O0120-013A-13
June 10, 2021

Re: **Village at Grafton Woods, 8 Pine Street
Plan Approval Application - Peer Review Response to Comments 2**

Last Saved: 6/10/2021 1:41:41 PM
Tighe & Bond 110000120 0013A-C-Permit Details.dwg
Figures\AutoCAD\Sheet\Permit Drawings\240120-013A-C-Permit Details.dwg

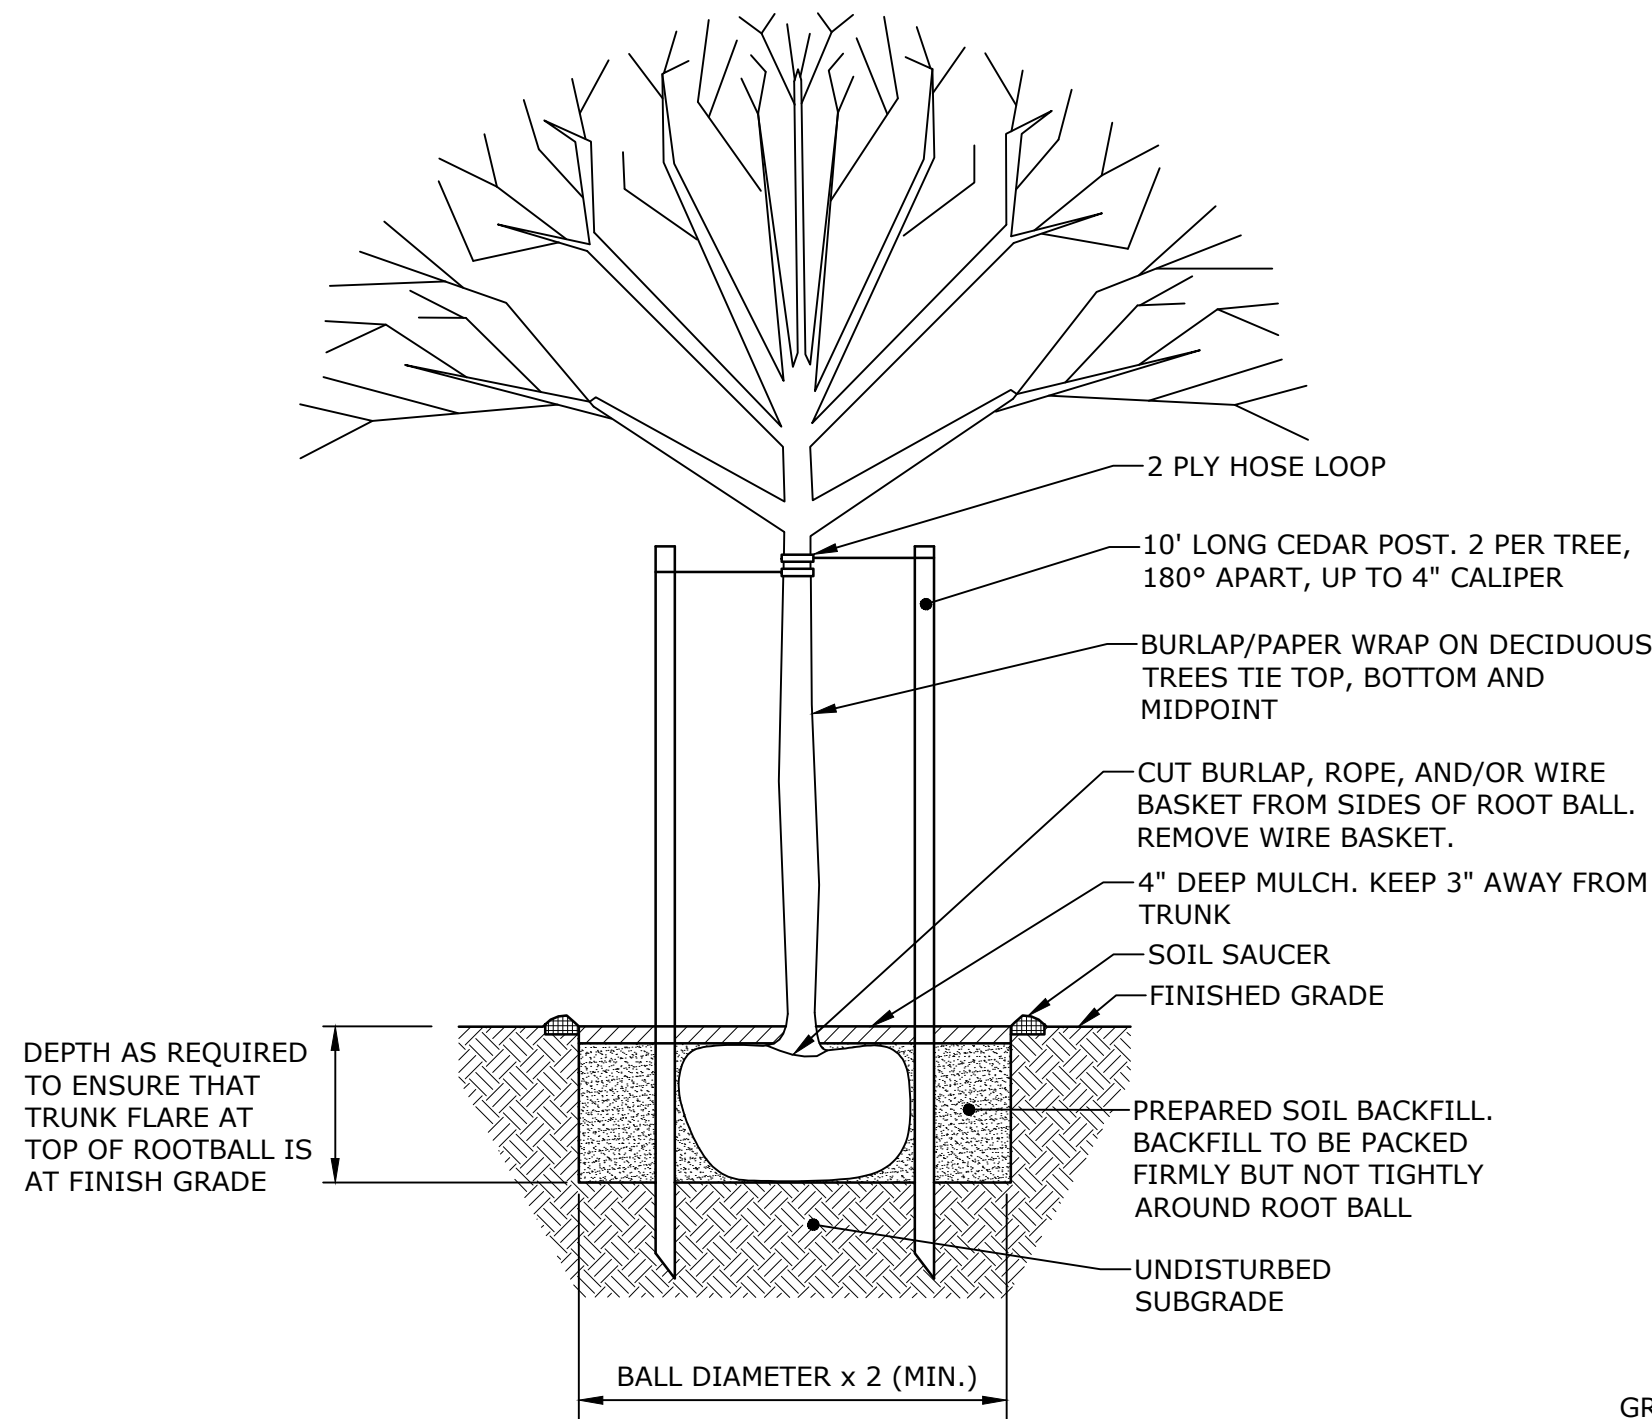
38. Pertinent elevations (e.g. bottom of stone, bottom of chambers) need to be provided on the plans for the subsurface infiltration systems.

T&B Response 6/10/21: Revised detail sheet C-507 has been revised to include pertinent design elevation data for each subsurface infiltration system. Detail sheets are attached to this letter.

DETENTION BASIN - BERM DETAIL
NO SCALE

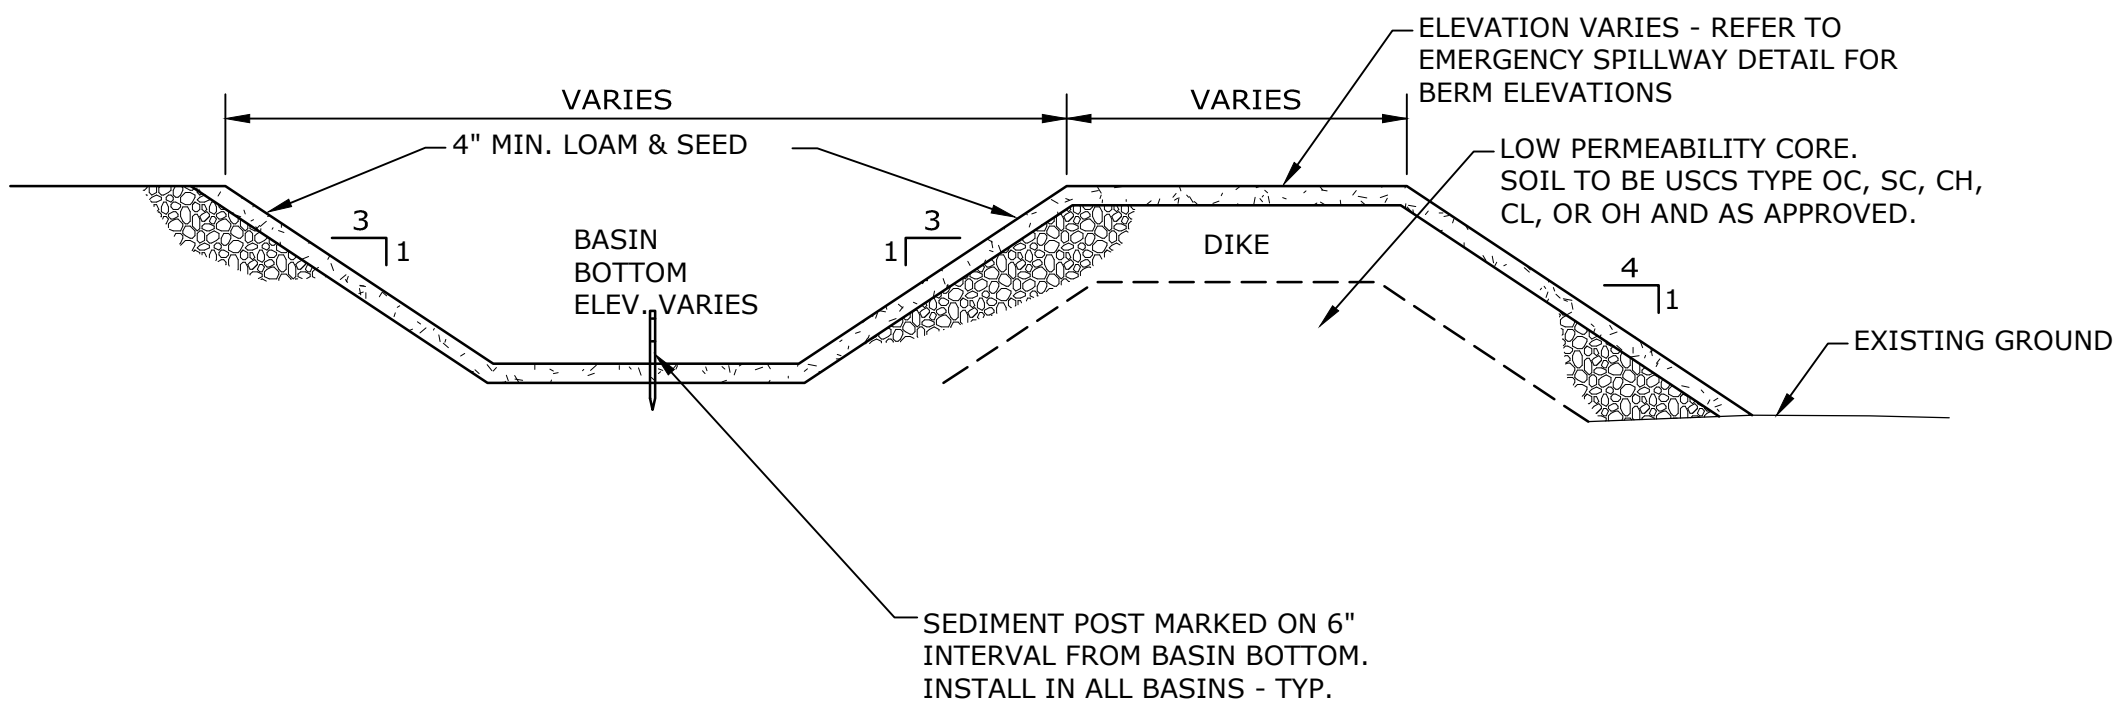
42. The top of the berm at the open infiltration basin will only be 3.5 feet wide at elevation 411.75 (the 411-foot contours are eight feet apart and the slopes are 3H:1V). The needs to be wide enough for maintenance equipment. (Grafton Wetland Regulations §V.B.5.h.ii)

T&B Response 6/10/21: Access to the basin for maintenance will occur from the Pine Street side which does not include a vegetated berm. The berm has been revised to provide a 10-foot width along the 411.75 elevation. This resulted in minor adjustments to the infiltration basin sizing, provided in the attached revised HydroCAD report. Revised drawdown calculations for the basin are attached to this letter.

- **Peak Water Elevation – 100-year storm event = 4410.24'**
- **Emergency Spillway Elevation = 410.75'**
- **Top of Berm Elevation = 411.75'**

C-509

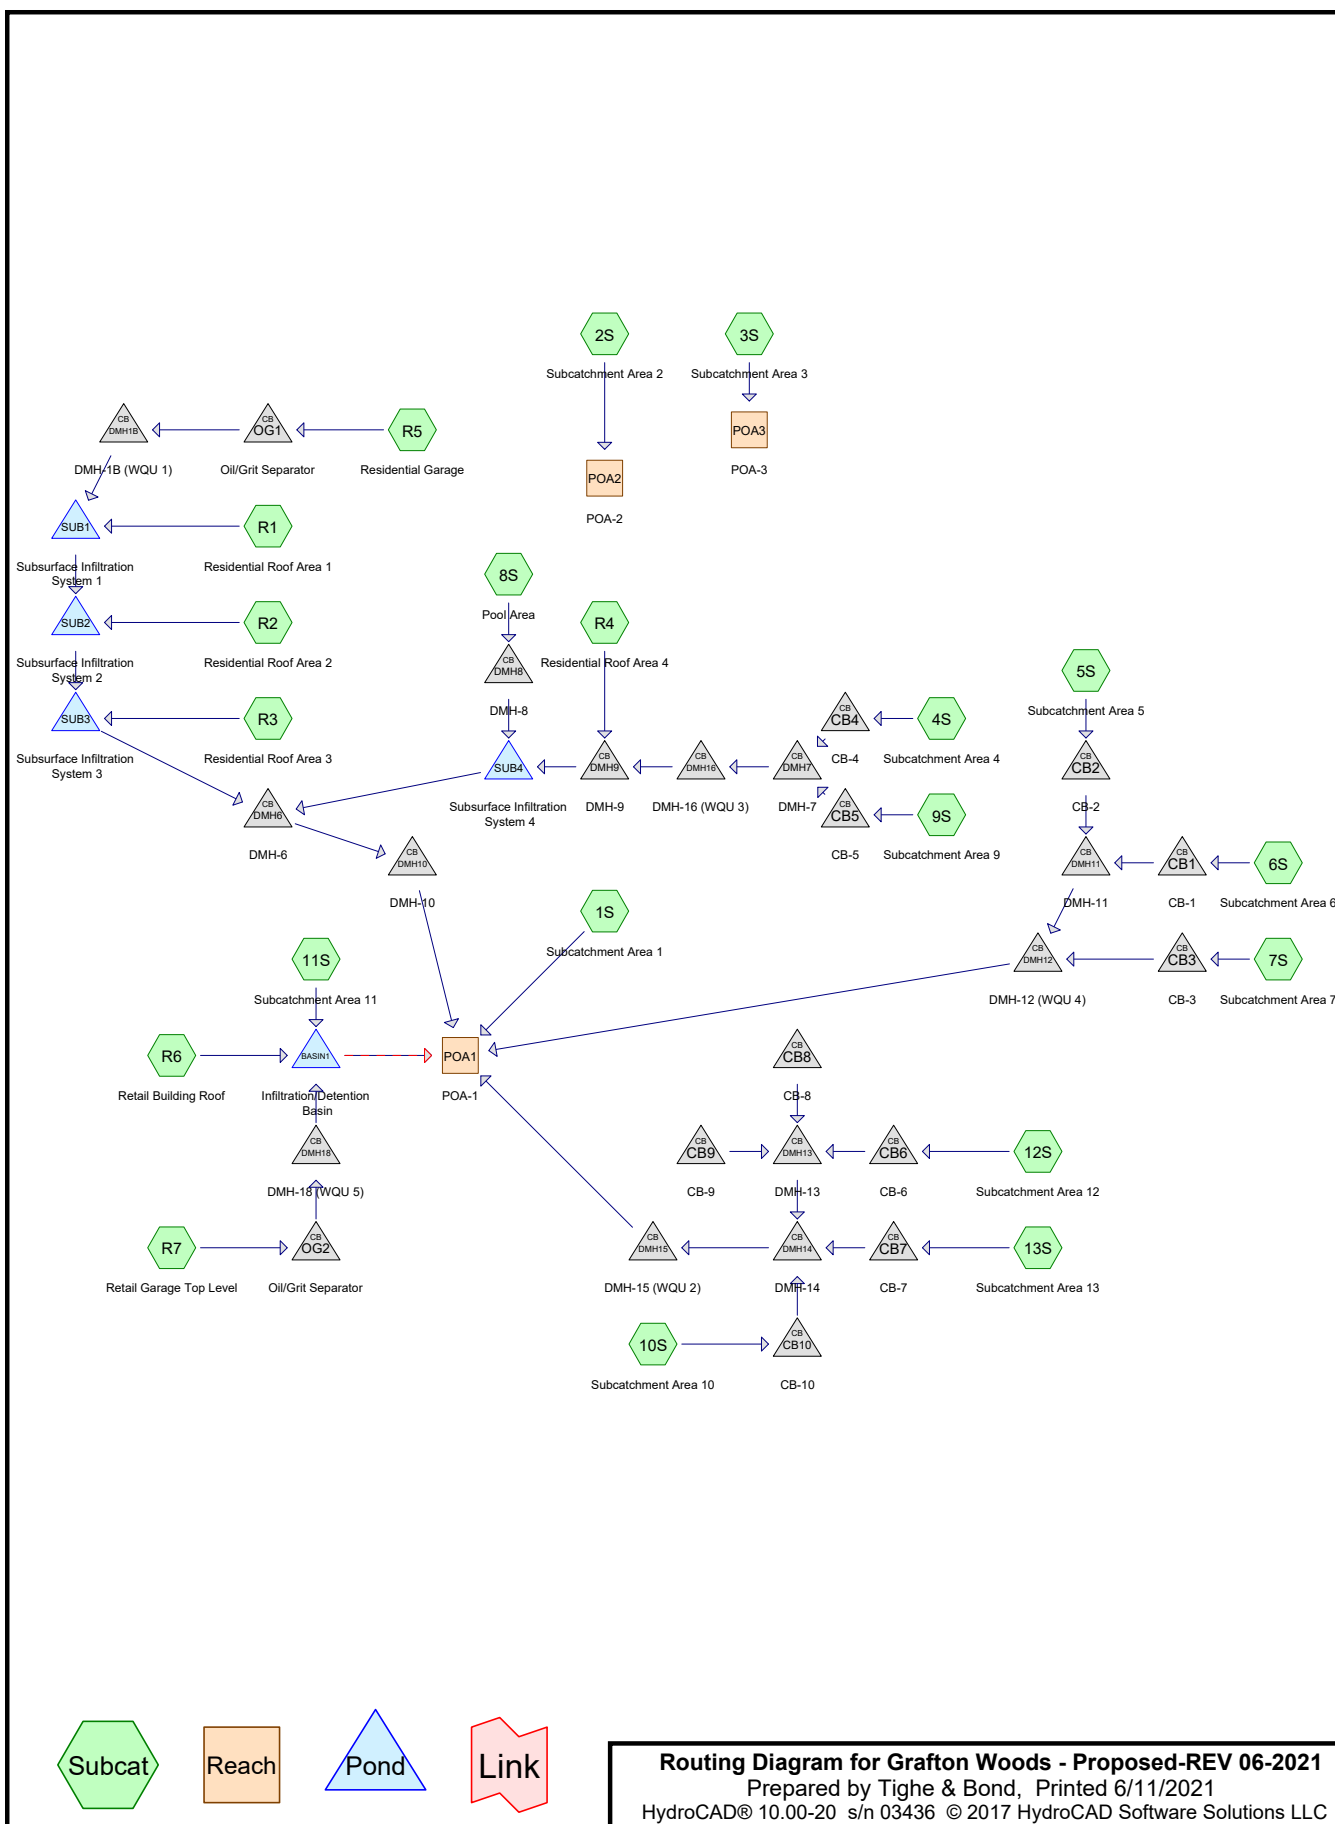
39. Proposed SMH 6 should be labelled as a drop manhole. GEI defers to the Grafton Sewer Department whether interior or exterior drops are required; in either case a construction detail should be added to the plans.

T&B Response 6/10/21: The Grafton Sewer Department requires an internal drop. Notations have been revised on Sheet C-107, and a detail has been provided on Sheet C-509, both attached to this letter.
